[Docket No. FAA-2016-9418; Product Identifier 2016-NE-23-AD; Amendment 39-19167; AD 2018-02-14]

#### Airworthiness Directives; Honeywell International Inc. Turboprop and Turboshift Engines

**ACTION:** Final rule.

**Figure 1 to Paragraph (h) of this AD. Combustion Chamber Case Assembly Without the One-Piece Bleed Pad with P3 Boss**

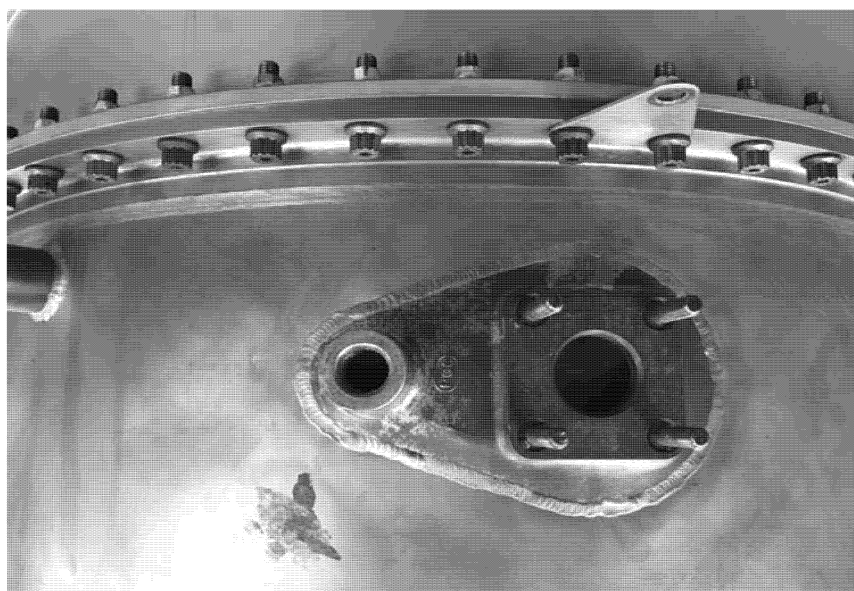
TPE331 model engines modified by STC SE383CH may be defined as the “Super 1” and “Super 2” for the compressor modification of the TPE331–1 and the TPE331–2, –2U, and –2UA engines, respectively. Figures 1 and 2 to paragraph (h) of this AD illustrate the appearance of combustion chamber case assembly, P/N

893973-5, without and with, respectively, the one-piece bleed pad with the P3 boss.
